Re: The Hub at Tucson III (No. T17SA00305) – March 2018 Design Package Changes

THE HUB AT TUCSON III

DESIGN PACKAGE - CHANGE SUBMISSION I **CHANGES TO OCTOBER 3, 2017 APPROVED DESIGN**

1 EAST ELEVATION
 1/16" = 1'-0"
 SCALE: 1/16" = 1'-0"
 0' 8' 16'

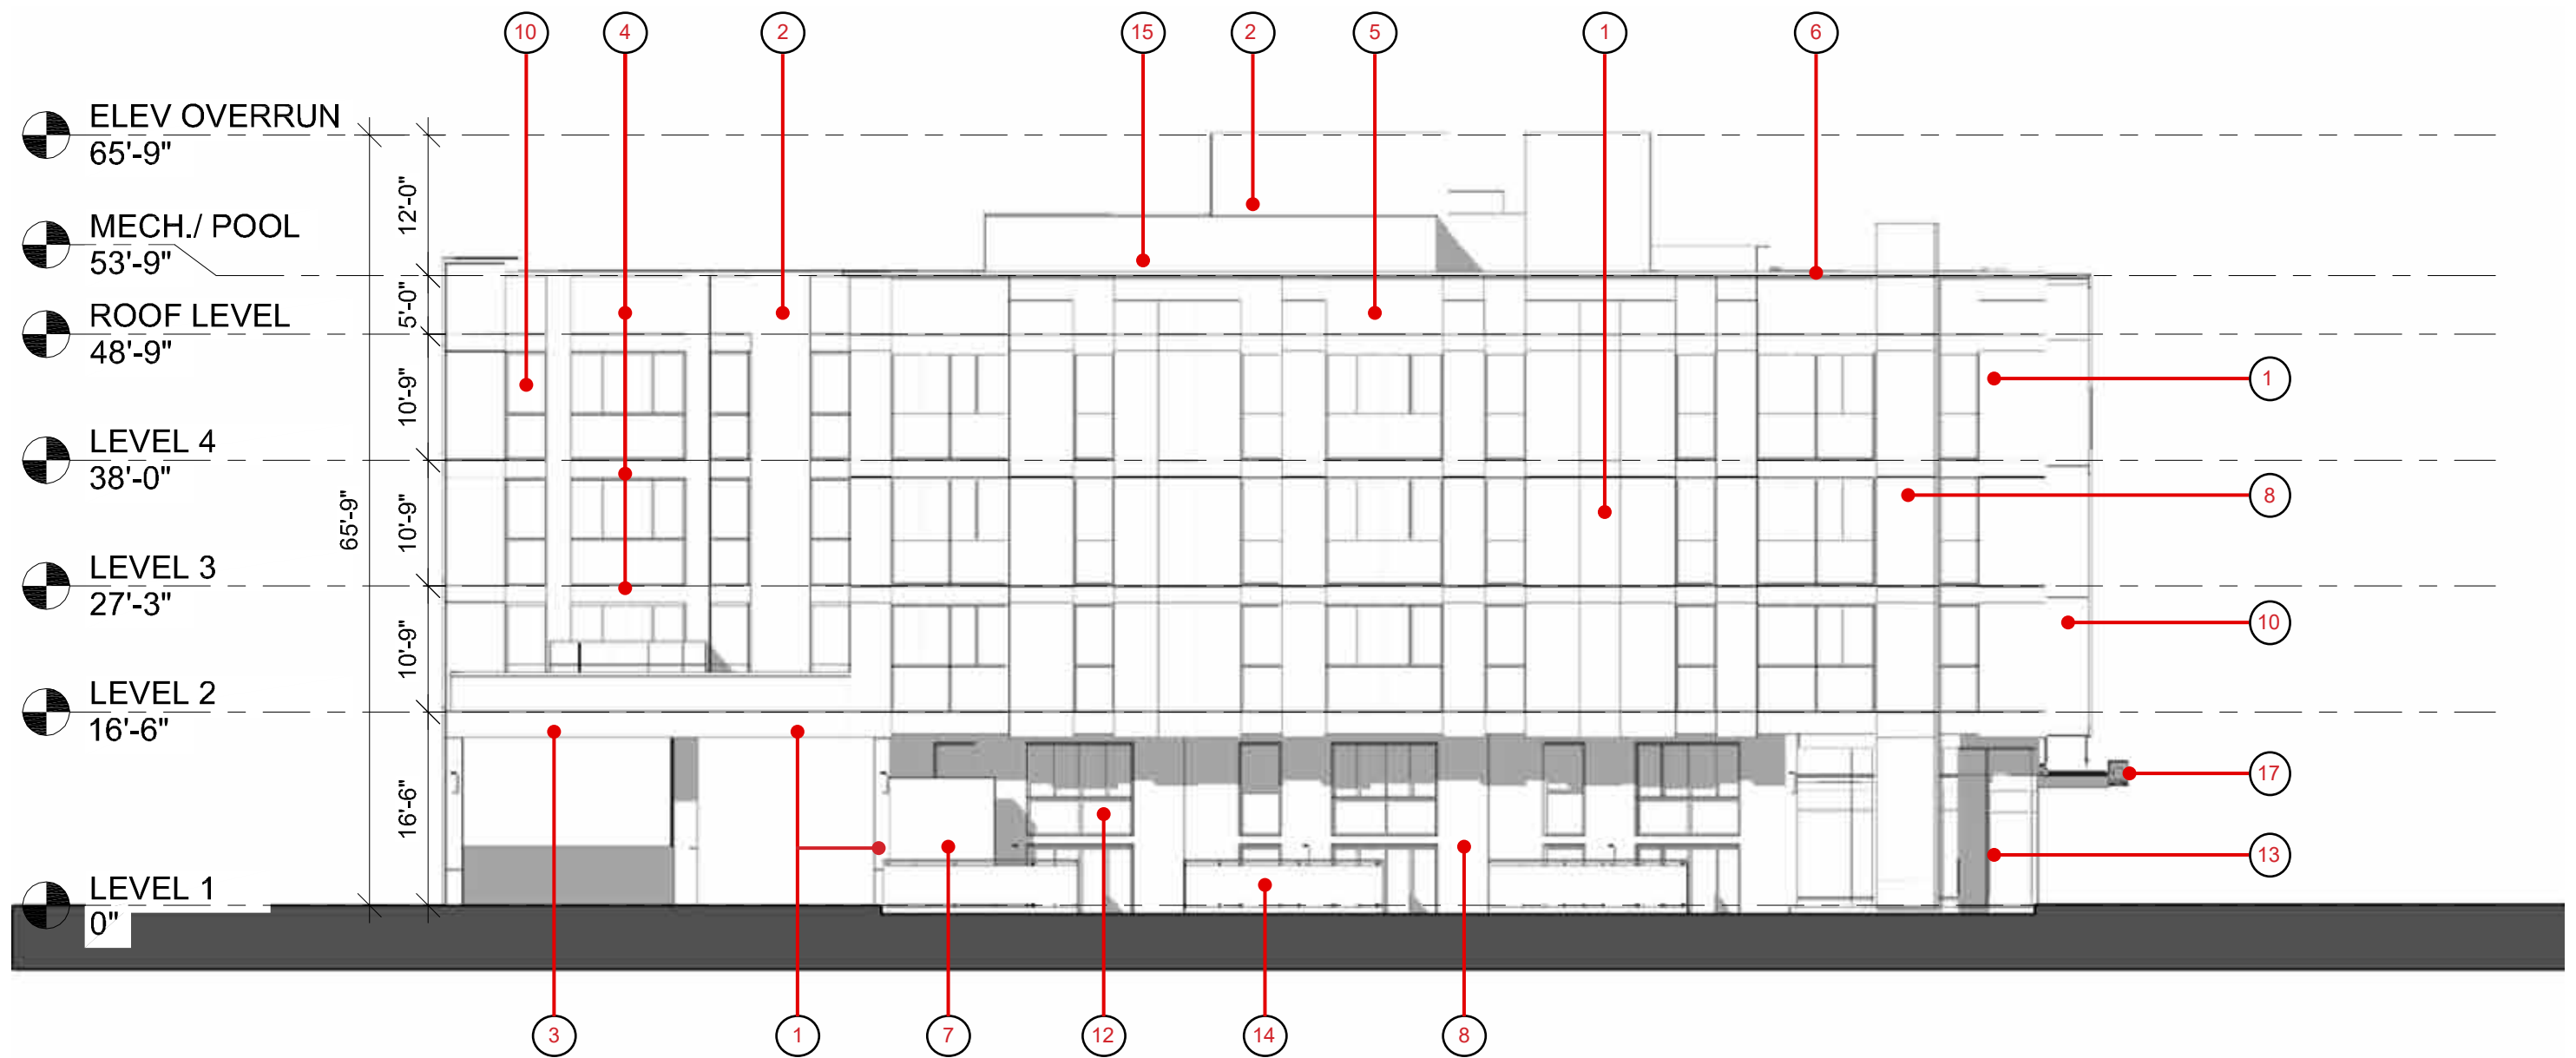
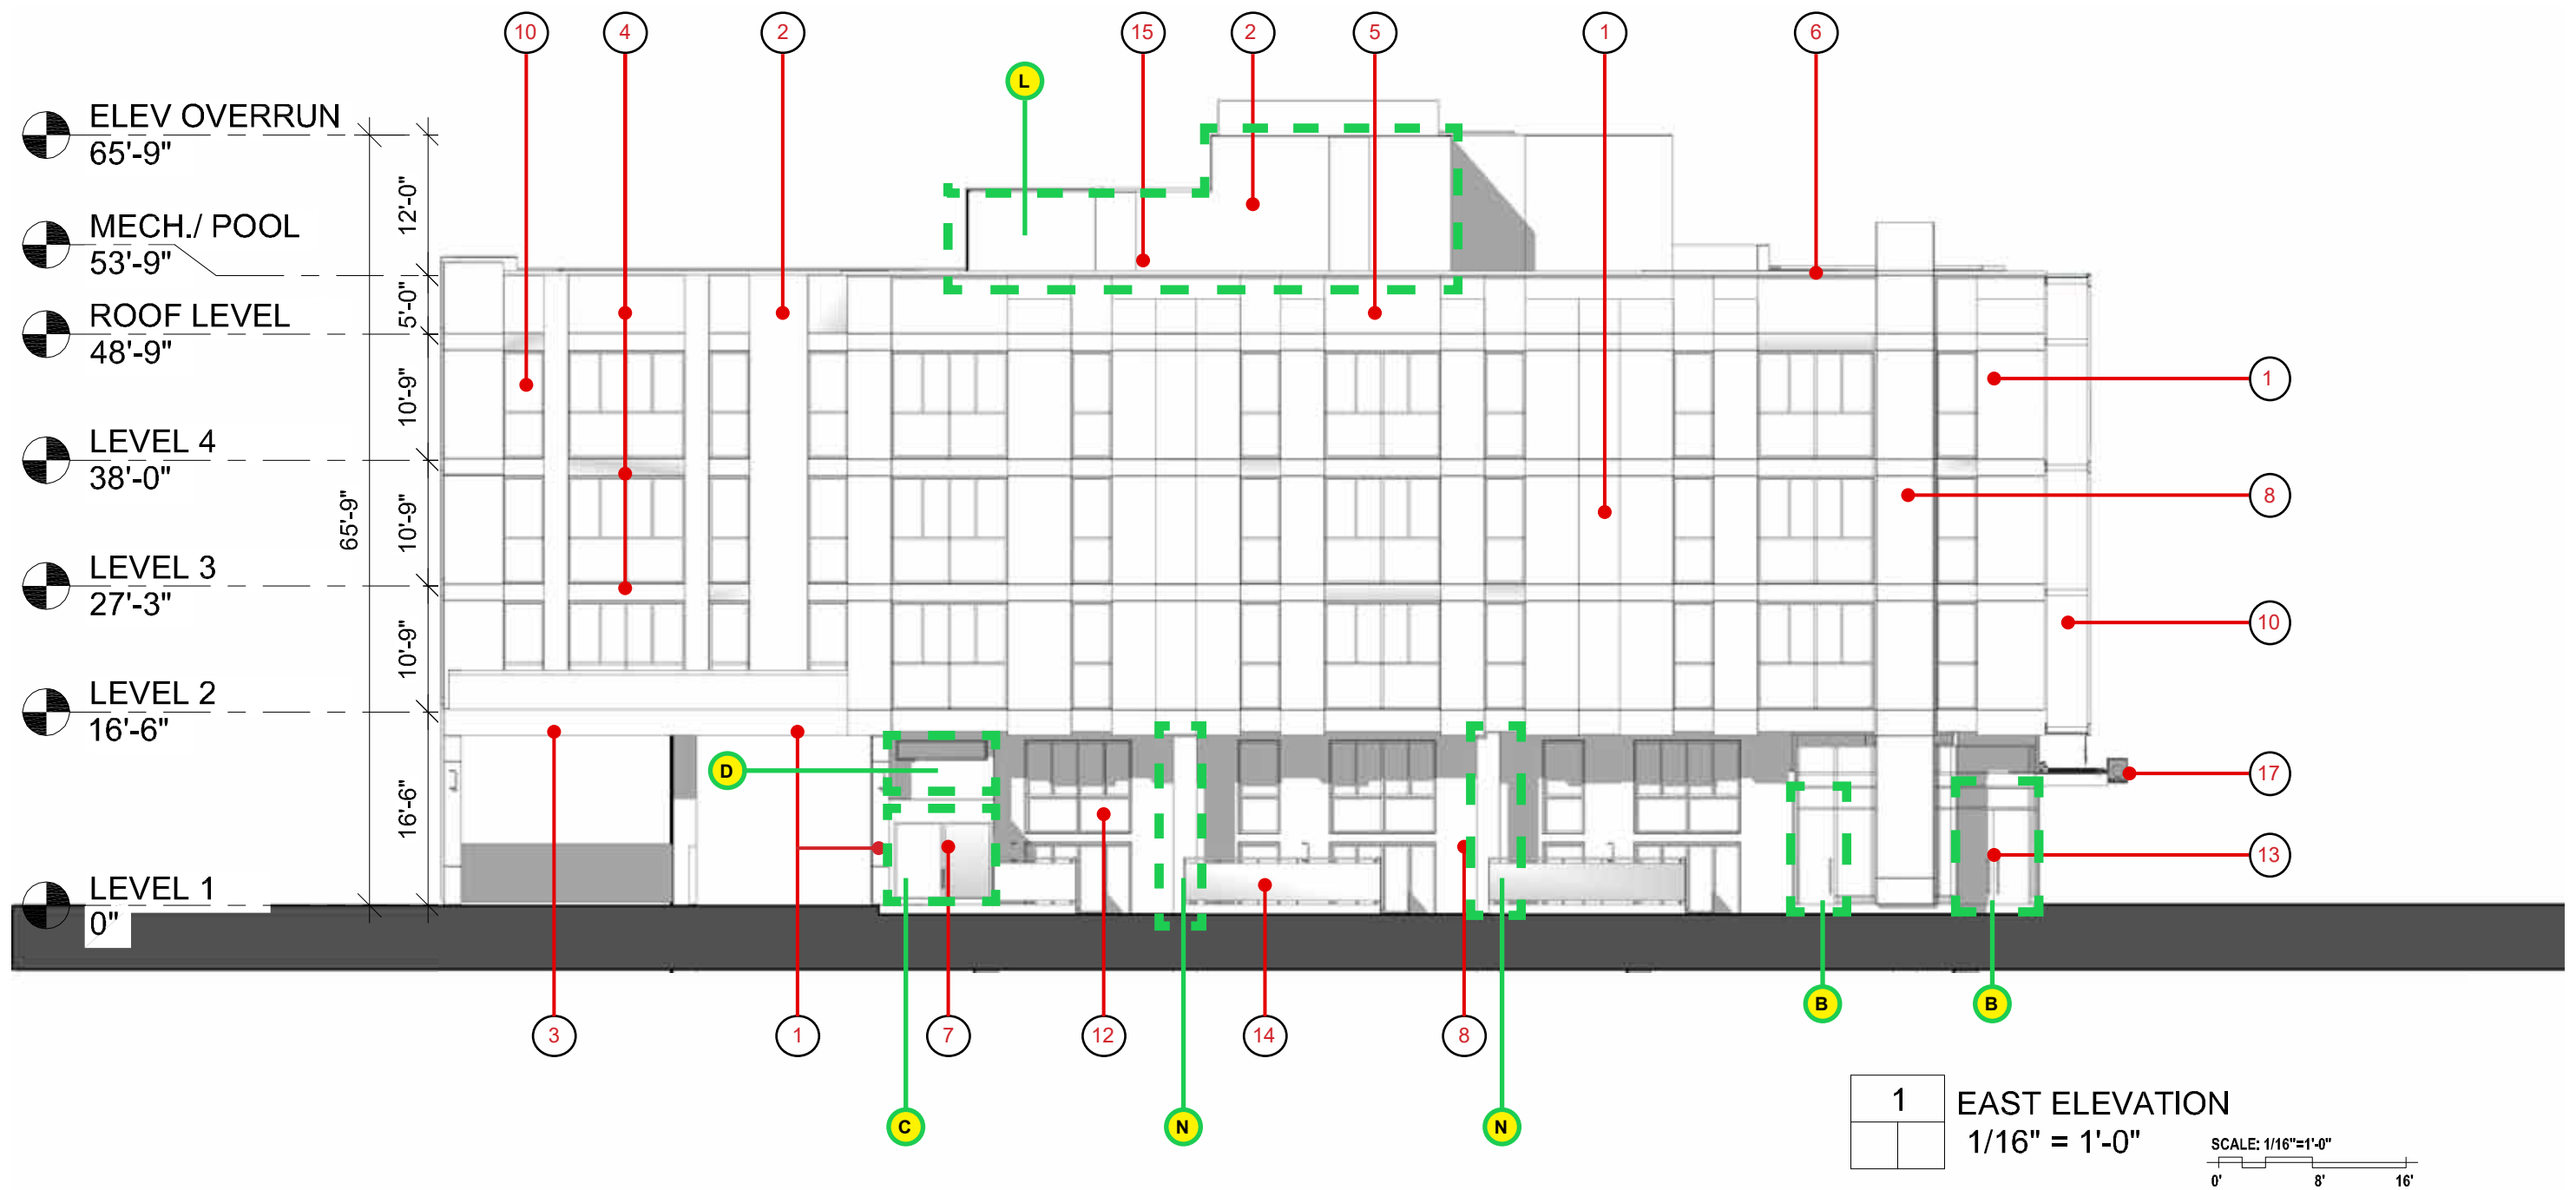
EAST ELEVATION

B,C,D,L,N

2. Residential Entry Reconfigured (Item B): The Project’s interior ground floor layout has changed, including a reconfiguration of the Project’s residential entrance. This interior change creates a new emergency exit door onto Tyndall, and shifts the main residential entry doors to the other side of the entry nook (i.e., the door now faces east, when it formerly faced north). The door material and design did not change. This reconfiguration of the residential entry design is a response to the unforeseen changes of the interior layout, and the changes are insignificant in that they do not change the overall look and design of the residential entrance.

3. Water Meter Enclosure Updated (Item C): The materials on the water meter enclosure (“Water Meter”) adjacent to Tyndall have been upgraded. The Water Meter’s original metal enclosure design has been replaced by a tile enclosure, using the oxidized-finish porcelain tile used on other areas of the Project. The Water Meter’s access doors will remain metal. The addition of the tile to the Water Meter improves its appearance from the Tyndall street frontage. This is a minor change to a small, but visible, area of the Project.

4. Townhouse Façade Adjustment (Item D): The original Project design created a five-foot gap between the back of the Water Meter and the wall of the southernmost townhouse. To improve safety, this gap has been almost eliminated by moving the townhouse wall to the east towards Tyndall. The repositioning of the wall eliminates the potential for people to hide near the townhouse entrance, increasing safety in this area. This design improvement is barely visible from Tyndall, and therefore is a minor change.

12. Pool Railing Material Changed (Item L): The original pool deck railing system was designed with glass inserts surrounded by metal frame. This design did not meet the City's Building Code and therefore the railing is now a solid wall system. The new wall system will be made from materials currently used on the Project. This change is a response to an unforeseen circumstance, and it improves safety by eliminating the potential for glass breaking along the rooftop pool. This is a minor design change that will not be visible from the surrounding areas due to the pool's location at the center of the Project.

14. Structural Columns Added on Tyndall (Item N): Two support columns have been added to the townhouse unit entrances facing Tyndall. This change responds to an unforeseen structural design requirement, in that the proposed cantilevered overhang must have structural supports. The addition of two columns on the Tyndall frontage to support the overhang has a minimal impact on design and therefore is a minor change.
